ENGINEER'S REPORT
of the
SAFETY OF MAW COMMUNICATIONS
FIBER OPTIC CABLE INSTALLATION

SAFETY OF MAW COMMUNICATIONS FIBER OPTIC INSTALLATION

ENGINEER'S REPORT

Figure 1 - PPL ADSS Fiber Optic Installation (outlined in yellow)

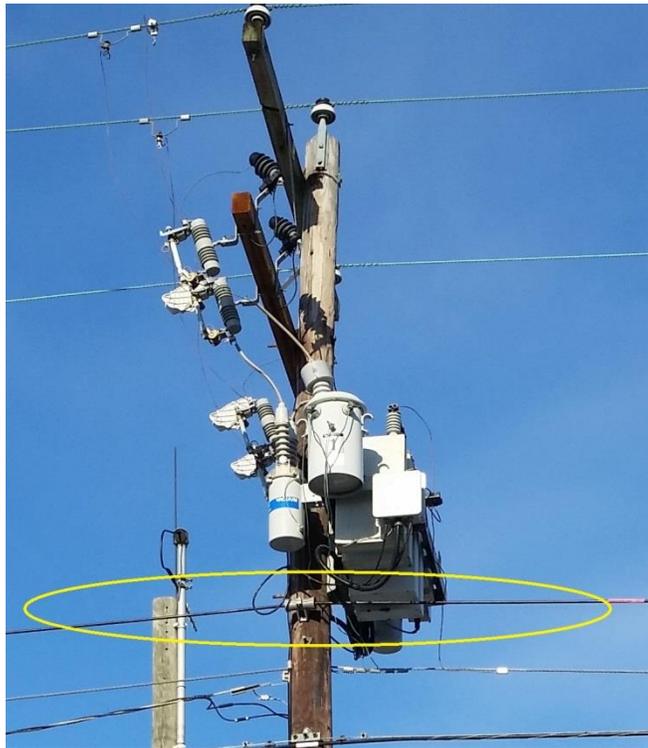
The below picture is of a PPL installation in Berks county that utilizes ADSS fiber optic cable with minimal clearance to supply. This is acceptable per the NESC, provided workers utilize supply space work rules.
